December 2, 2016

SUBJECT: **Modification Request of Section 404 Regional General Permit No. 31 and Section 401 General Water Quality Certification No. 3886** for the proposed Interstate 85 (I-85) Widening and Interchange Improvements from north of NC 73 (Davidson Highway / Exit 55) to north of SR 2180 (Lane Street/Exit 63), Cabarrus & Rowan Counties, Divisions 9 and 10. Federal Aid Project No. FANHIMF-085-2(61)55, TIP Project No. I-3802A.

PERMIT DRAWING SHEET 63 OF 122
MODIFICATION
 10/26/2016

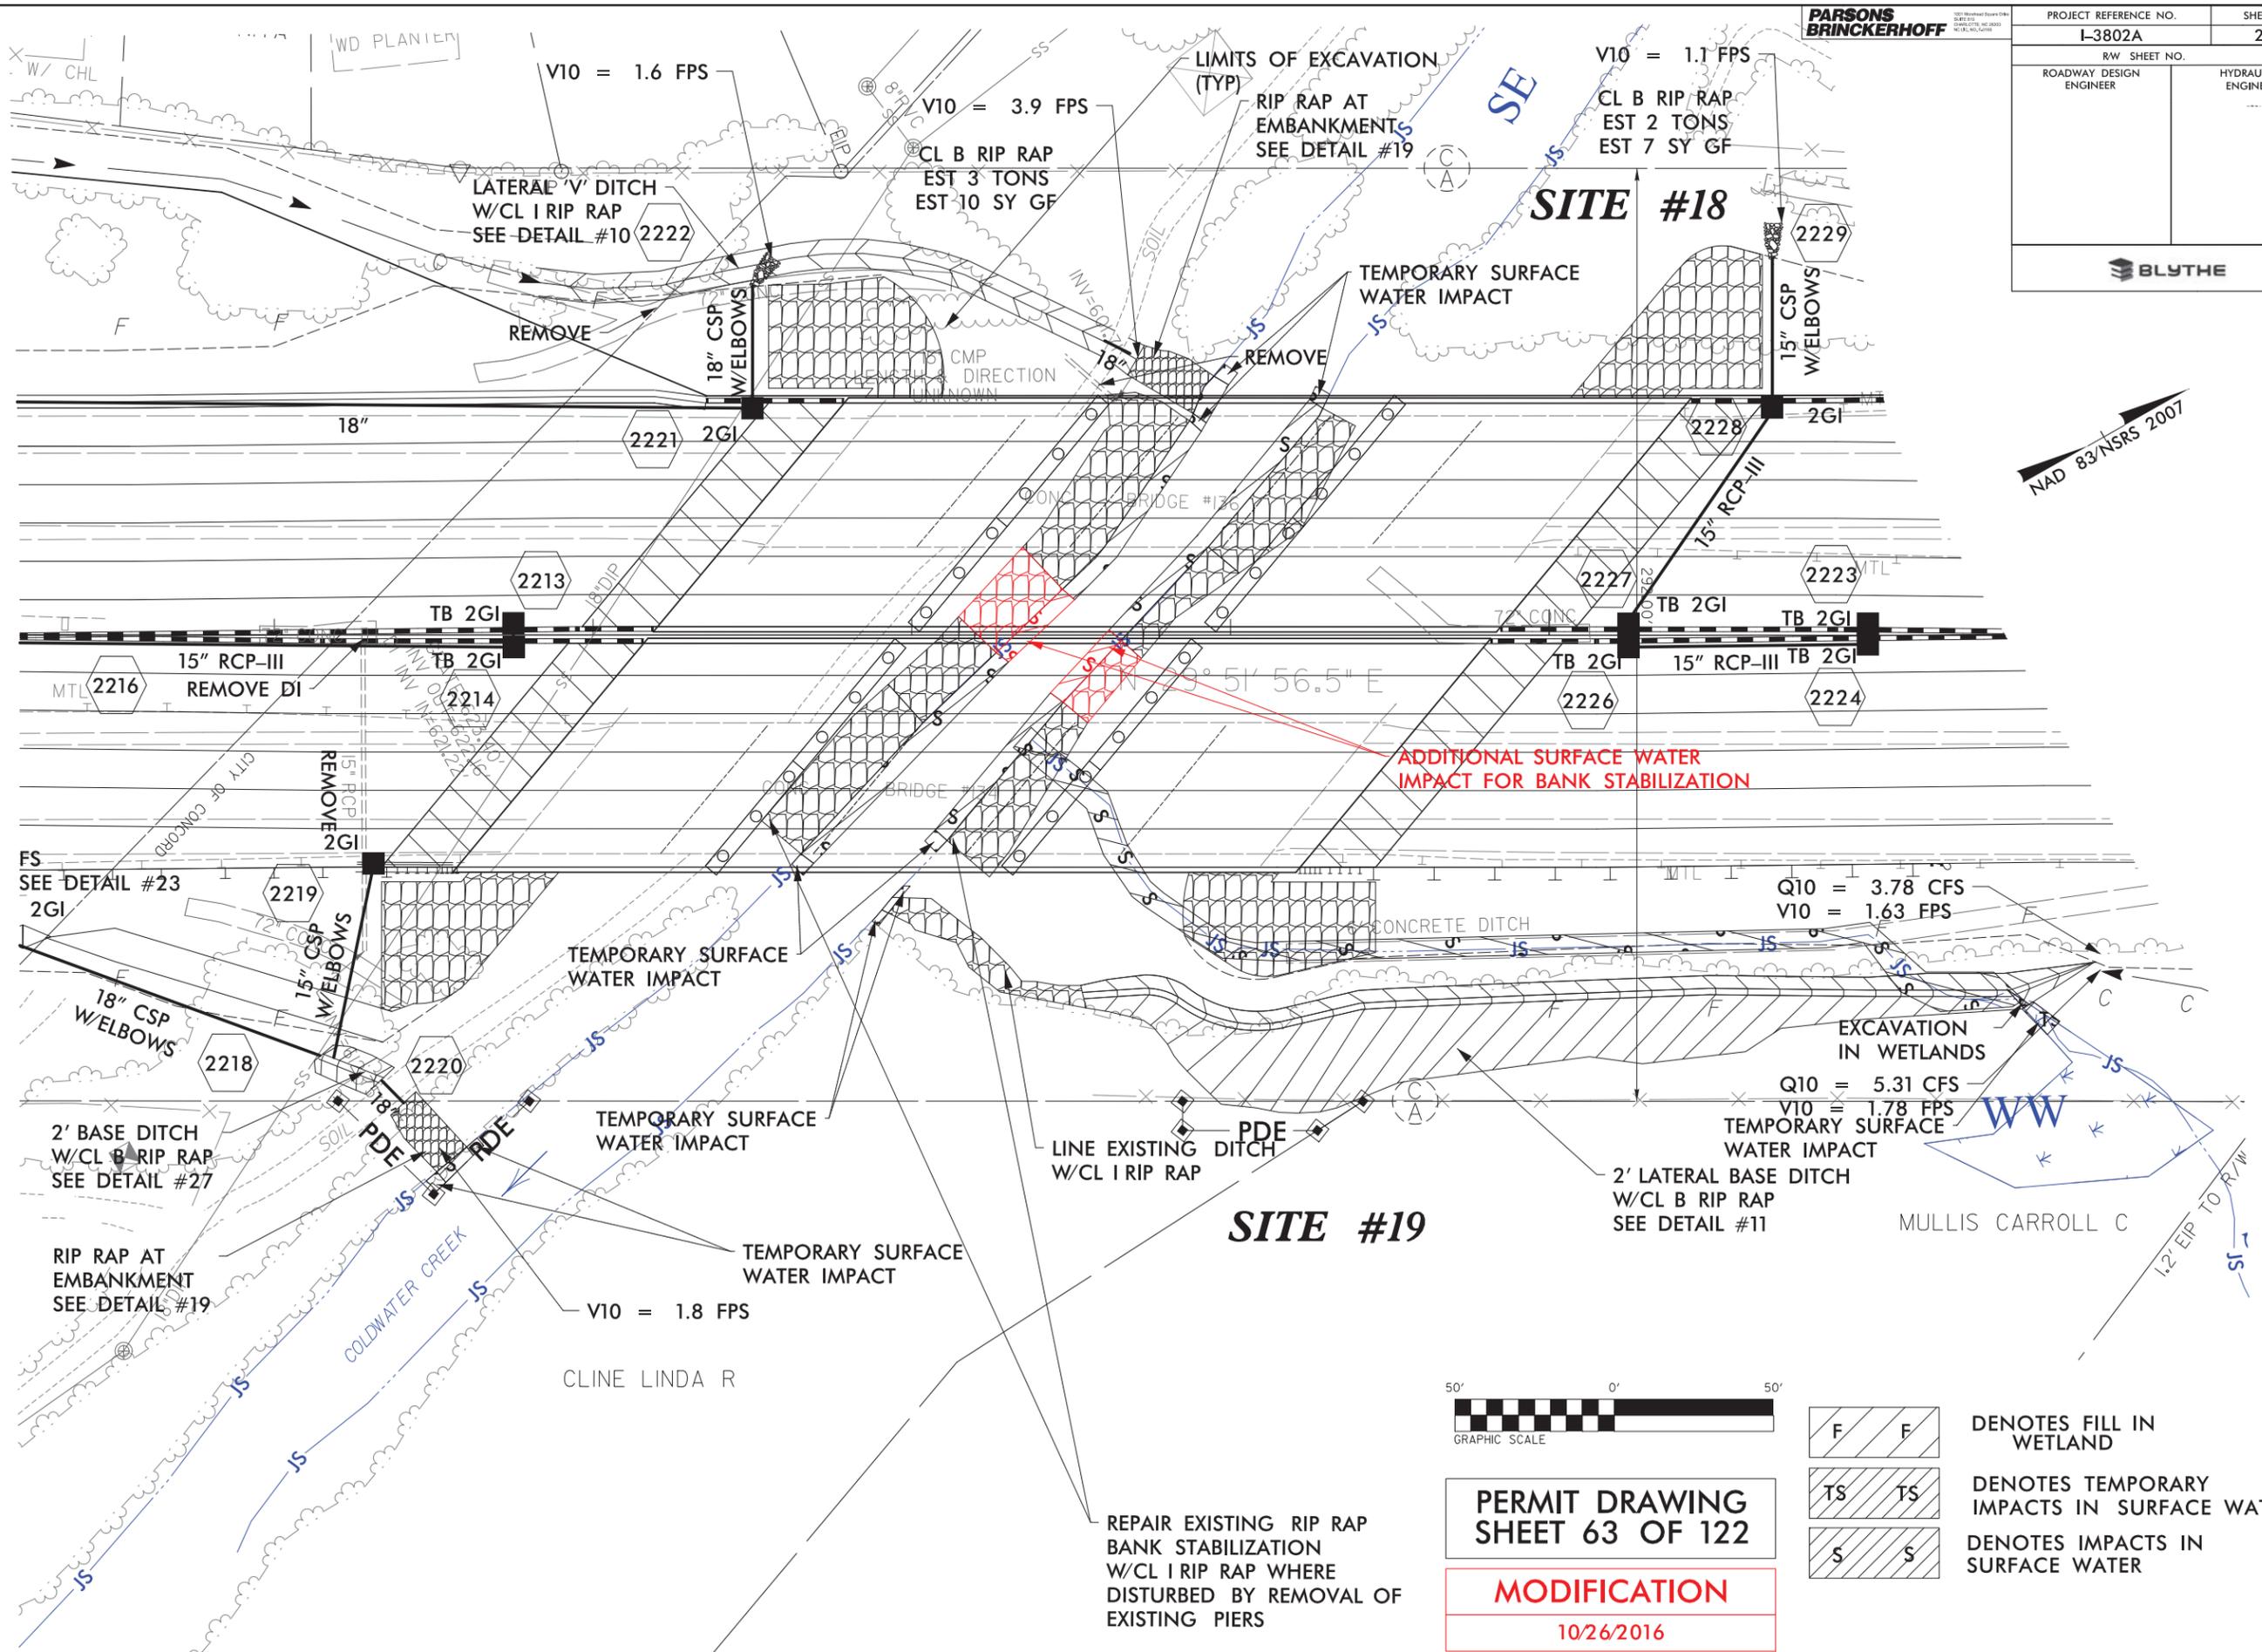
On November 17, 2015, representatives from NCDOT met on site with Ms. Donna Hood (N.C. Division of Water Resources [NCDWR]) to conduct a project review. During the site meeting Ms. Hood recommended that additional riprap be placed under the Cold Water Creek Bridge. The contractor also required a temporary crossing at the same

location. A modification request for the addition of 66 linear feet of temporary stream impact due to the placement of the temporary causeway and 30 linear feet of permanent impact due to bank stabilization at Site 18 was initially requested on February 18, 2016. The modification to the Section 401 certification was approved by NCDWR on March 22, 2016. The Section 404 modification request has not yet been approved by the U.S. Army Corps of Engineers (USACE). Since the February submittal, it has been determined that the temporary crossing is no longer needed. Additionally, the riprap bank stabilization was installed at the site by the contractor prior to receiving the USACE permit modification, most likely due to a misunderstanding that both the Section 404 and 401 modifications had been approved. The previously approved 185 linear feet of stabilization, which was permitted by the original permit, and the additional un-permitted 30 linear feet included in the last permit modification request has already been installed at the site.

PERMIT DRAWING SHEET 35 OF 128

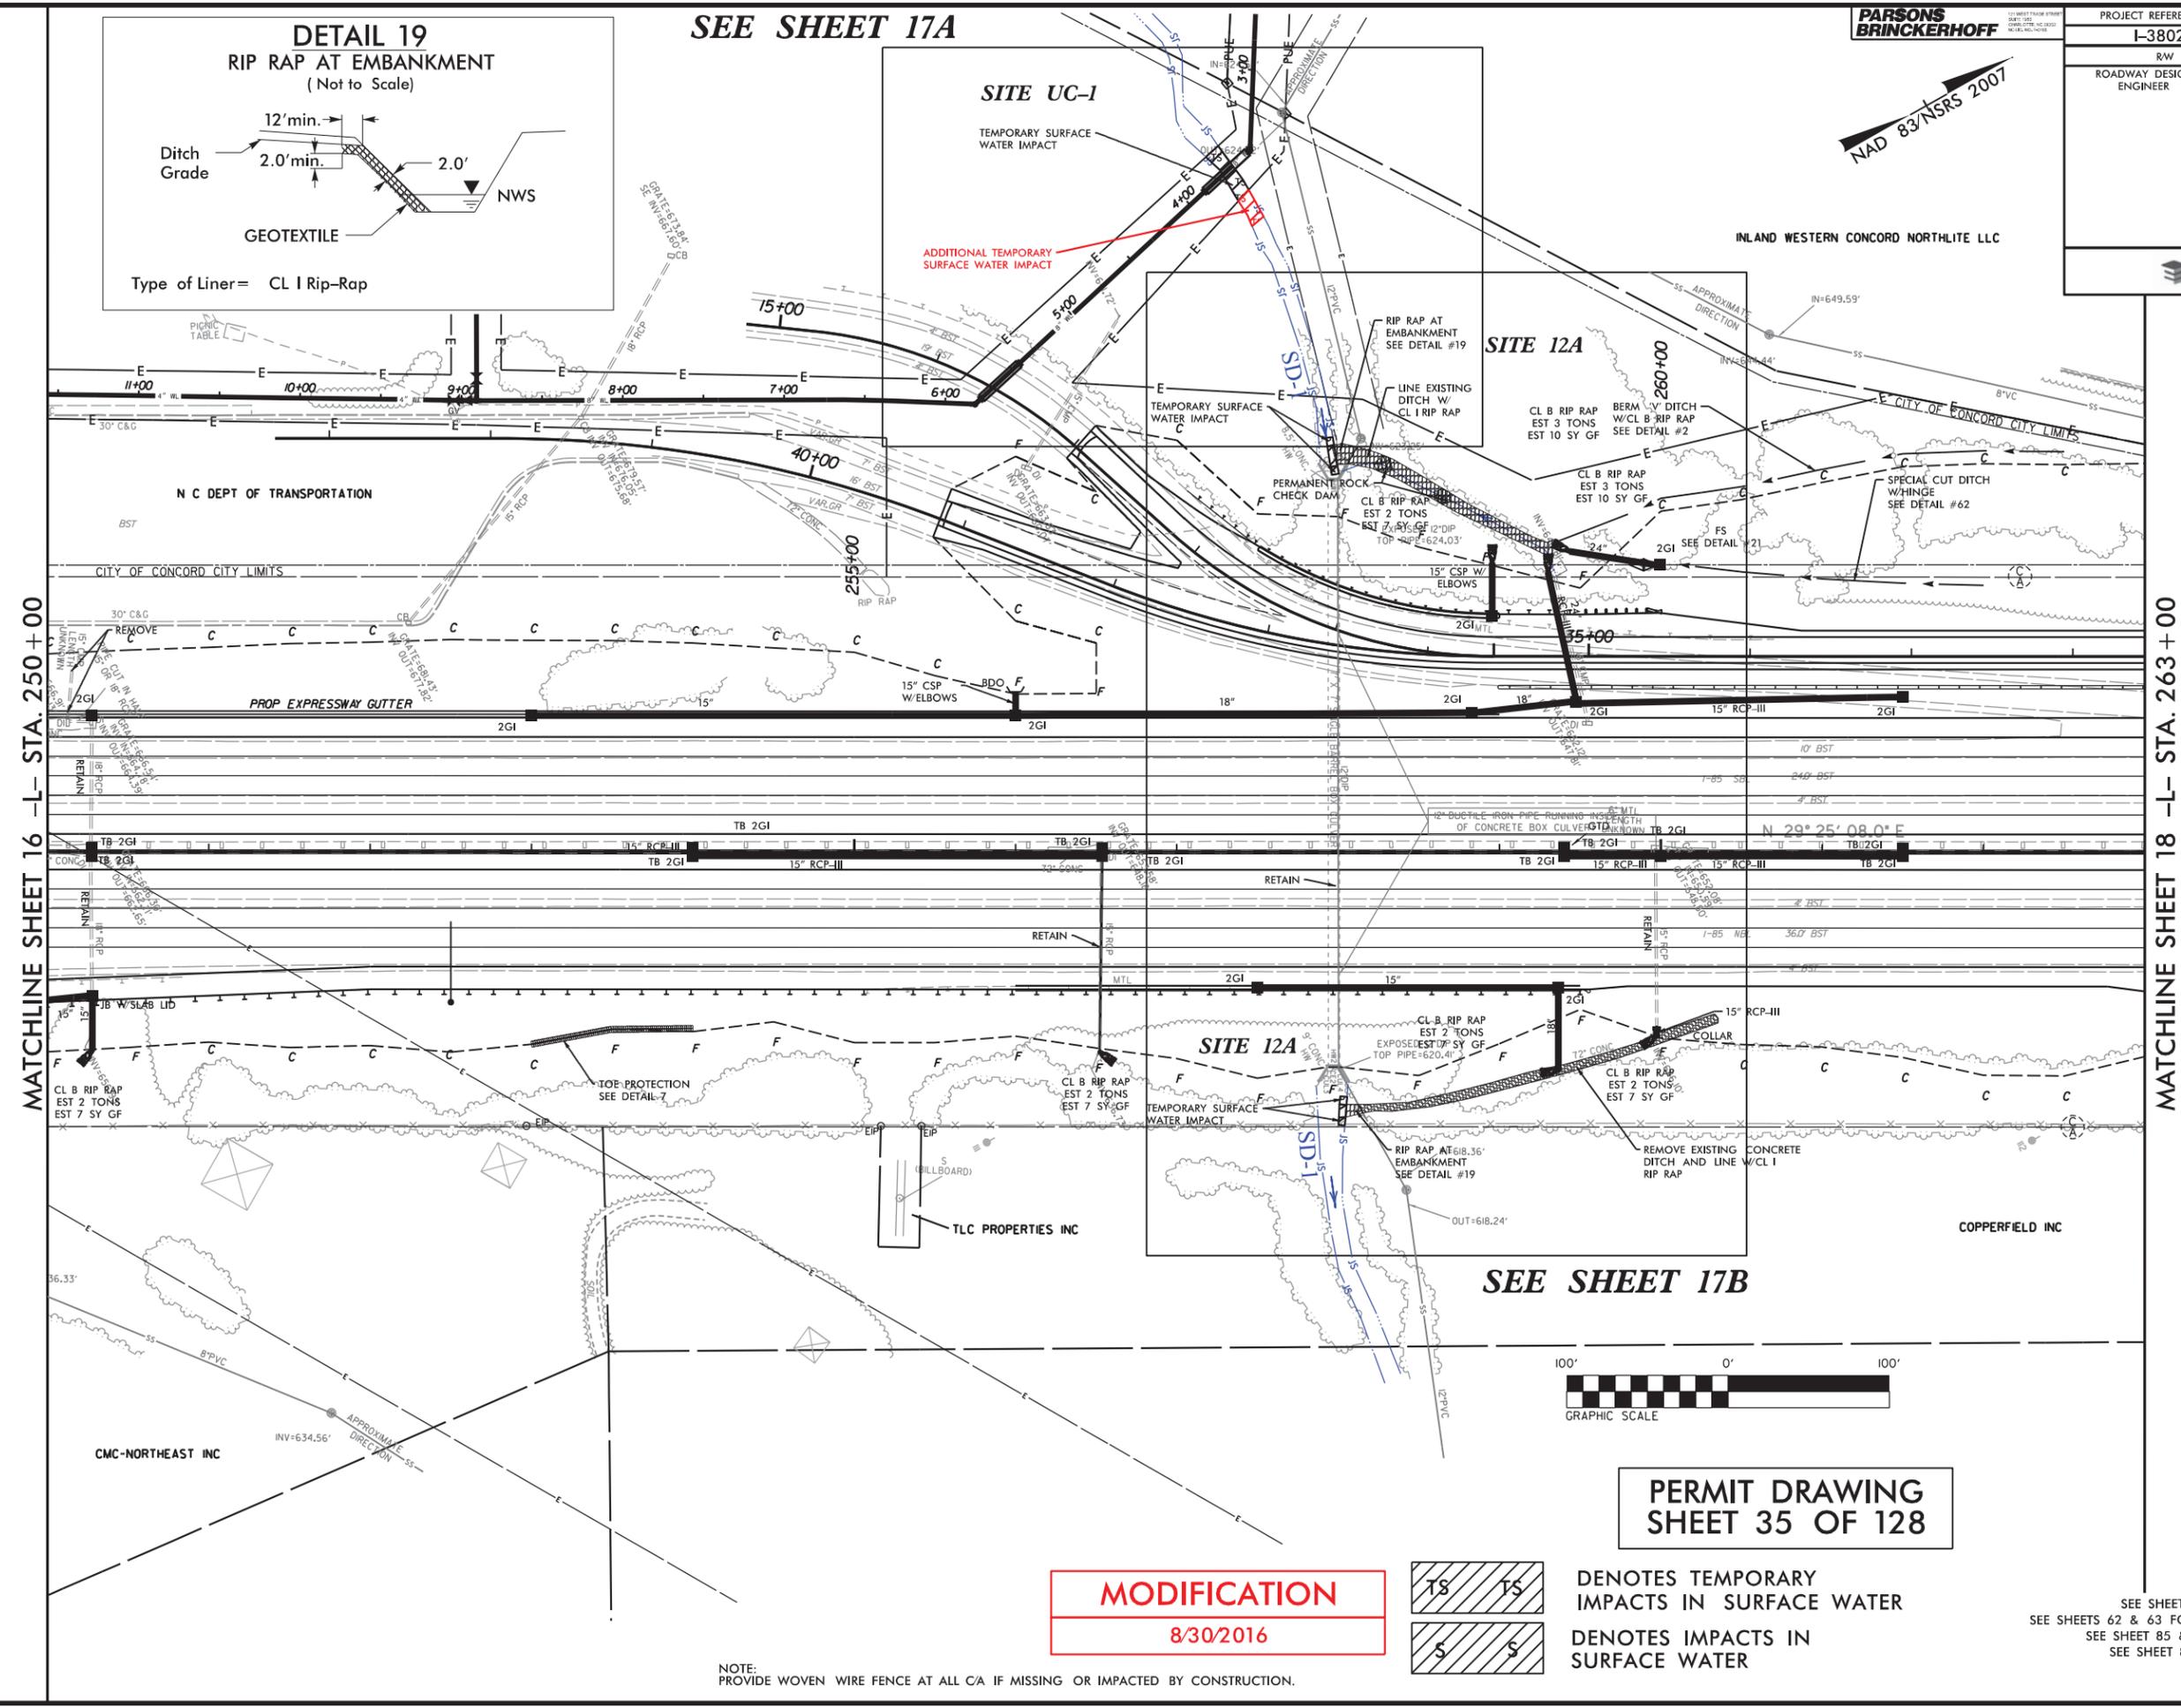
On July 19, 2016, representatives from NCDOT met on site with Ms. Donna Hood to conduct a project review. During the site meeting Ms. Hood measured additional unpermitted temporary impacts of approximately 16 feet in length to Site UC-1. During the site prep for the installation of the proposed waterline, additional areas were cleared along the stream banks. The clearing impacts were necessary for the installation of the waterline and to allow for a dry work area. Ms. Hood recommended that these additional impacts be included in the next permit modification. Ms. Hood contacted Ms. Crystal Amschler (USACE) via email on September 21, 2016 to inform her that she had observed the aforementioned impacts and had made recommendations to the contractor regarding a time frame for submission of the modification request.

The temporary surface water impacts associated with the waterline installation overrun resulted in an additional 19 linear feet of temporary stream impact per the contractor's field measurements (this is the same area as the 16 feet referenced above, but a more

accurate measurement). The proposed impact total for Site UC-1, including the previously-permitted impacts and the currently unpermitted impacts are 56 linear feet of temporary stream impacts. No other changes to permitted wetland and stream impacts are proposed for Site UC-1.
